Effect of Faults on Groundwater Flow in the Carrizo-Wilcox Aquifer in Central Texas: Update the Central GAM for Sparta, Queen City, Carrizo-Wilcox Aquifers

**Stakeholder Meeting #1
November 20, 2015**

List of Stakeholders' Question and Comments
1st SAF: Effect of Faults on Groundwater Flow in the Carrizo-Wilcox Aquifer in Central Texas:
Update the Central GAM for Sparta, Queen City, Carrizo-Wilcox Aquifers
November 20, 2015
Milano Civic Center
Milano, Texas

Fault Zones

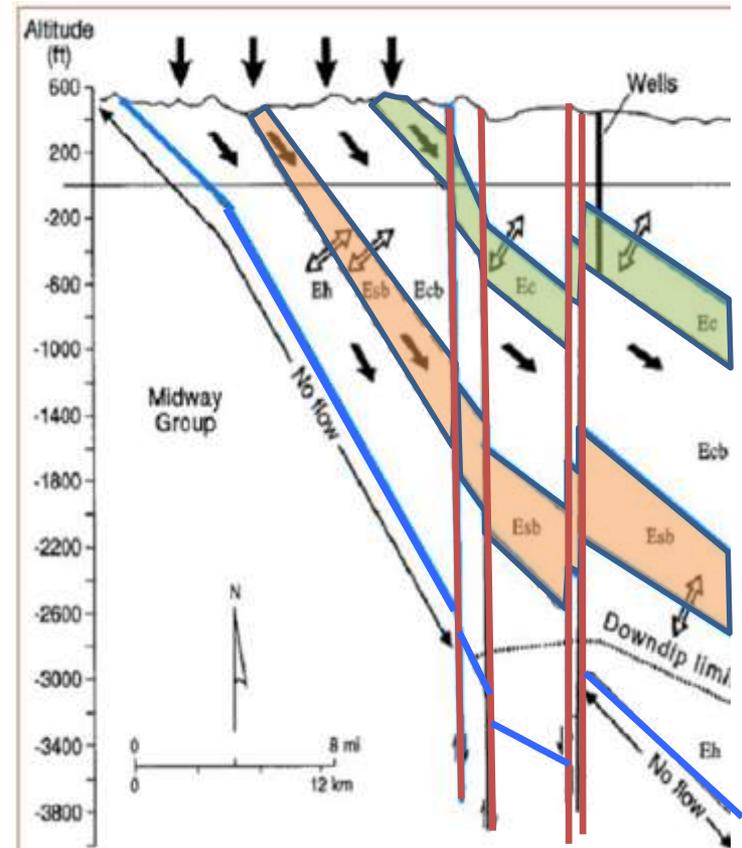
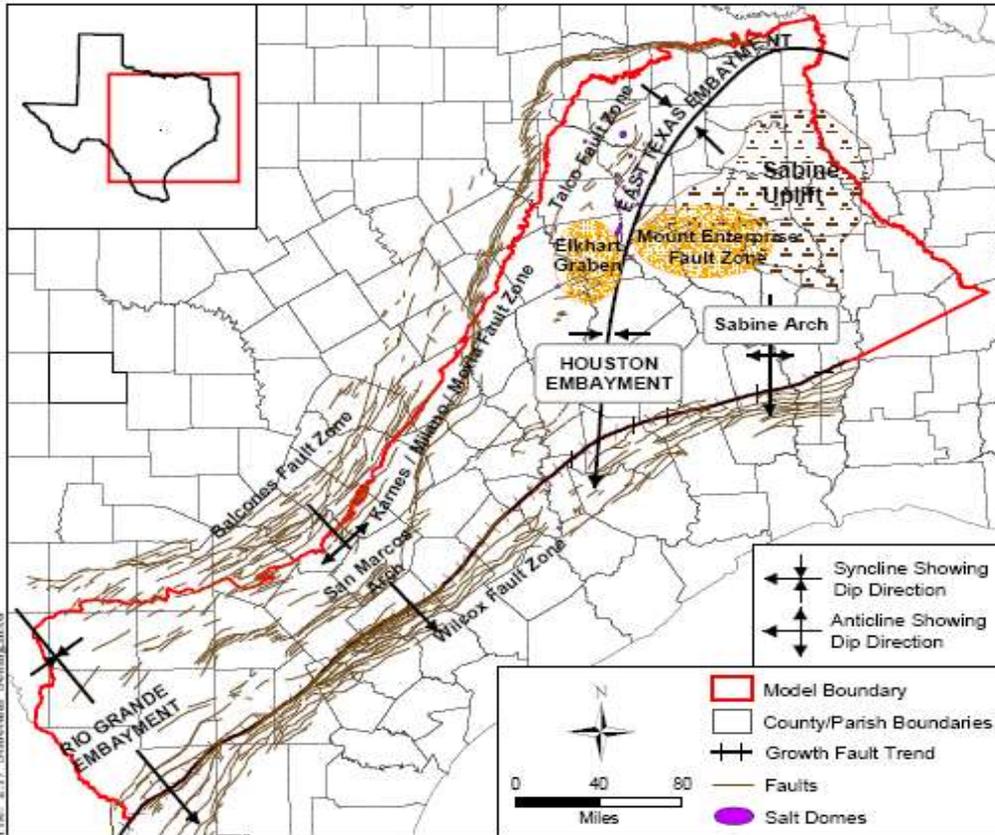
1. **Stakeholder:** The numerous faults at the up-dip extent of the geopressured zone shown in Slide 7 could partially account for why the high pressures still exist down-dip of the faults.
Response: Agreed. There is a very good paper that explains the geopressured zone downgradient of the Wilcox fault zone written by Dutton and Kier. The longevity of the geopressure zone occurs partly because of the clay layers of very low permeability that trap the high pressure.

Mining Block Aquifer Test

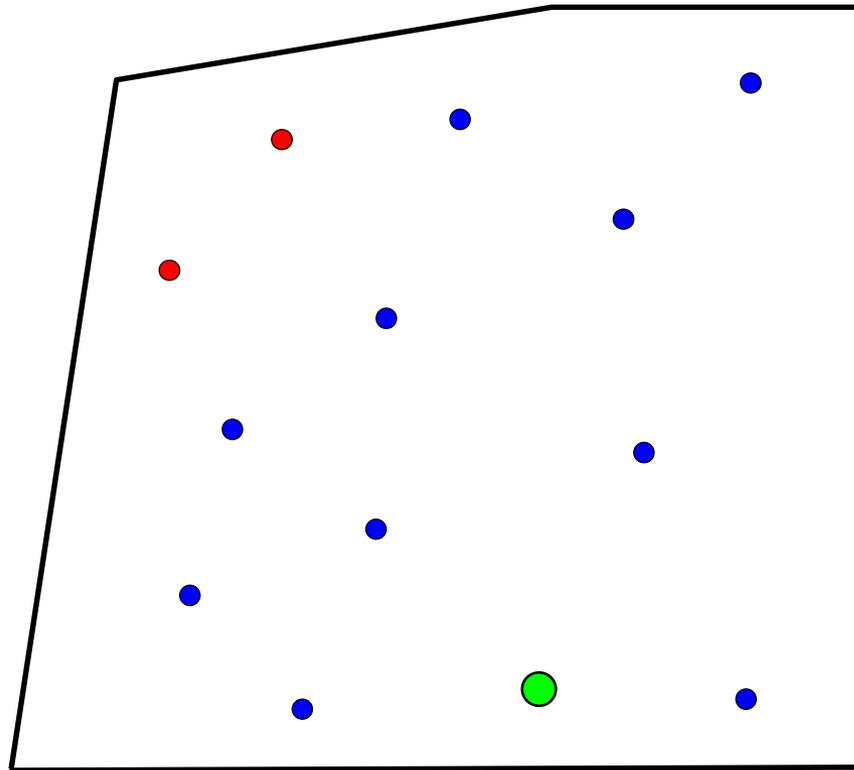
1. **Q.** What was the size of the mine block on slide 21?
A. The area is about 3,000 acres.
